**M2 Site within the North Ryde Station Urban Activation Precinct SSD
5093**

North Ryde Station Precinct

State Significant Development Application – M2 Site

City Of Ryde

Figure 4 - Amendment 1 Road Network

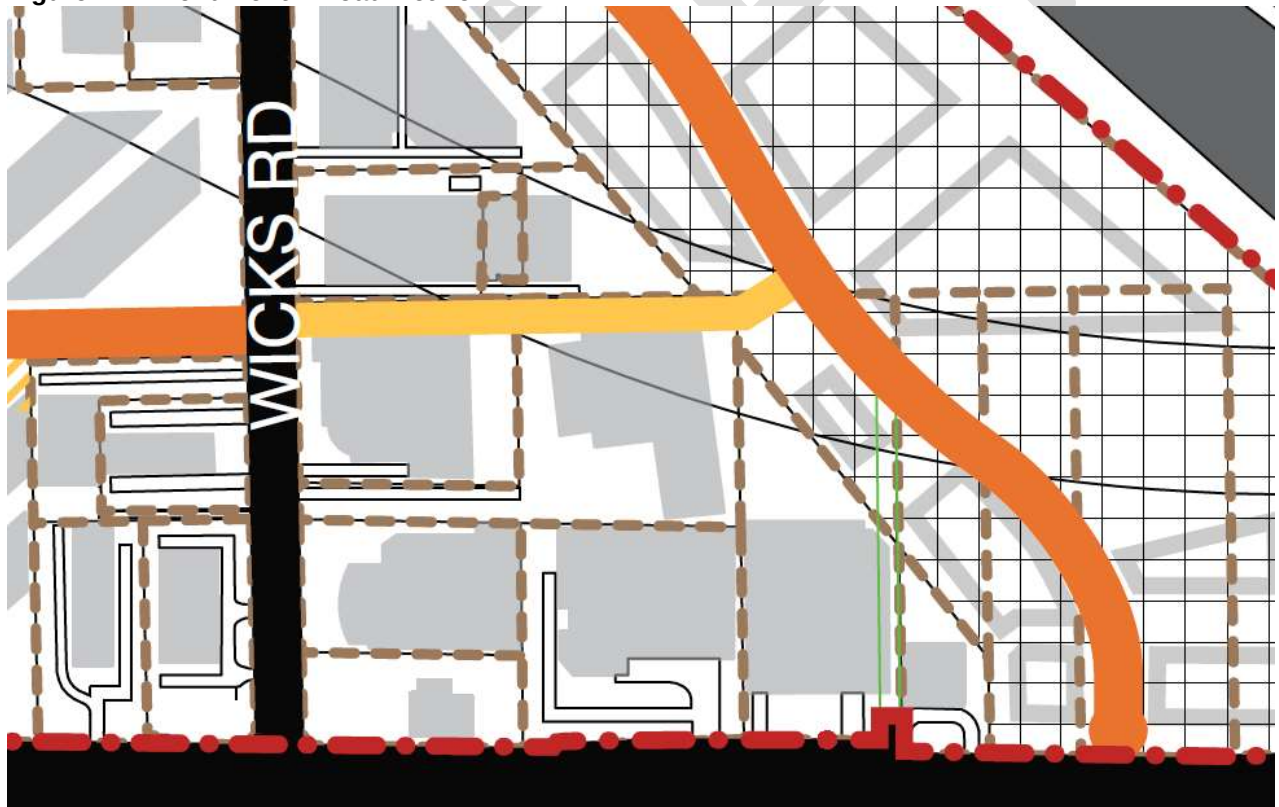
It is noted that the proposed subdivision plan has identified Lot 109 as being the location of a future road connection. Council is currently in the process of finalising a Planning Proposal for Macquarie Park which seeks to rationalise the road network detailed within the existing controls. This Planning Proposal and supporting documents is generally referred to as Amendment 1. Amendment 1 identifies that the proposed road connection is to be located at the northern most boundary of 11 and 113 Wicks Road. This proposed road network is detailed within Figure 4.

The road connection as identified is predicated on a recent planning proposal that was not supported by Council seeking residential land uses on 111 Wicks Road, 29 Epping Road, 31-35 Epping Road, Macquarie Park. This planning proposal is currently undergoing a Gateway Review with no definitive outcome at this stage.

As such, Council strongly recommends the amendment of the SSDA to reflect the future controls proposed for Macquarie Park.
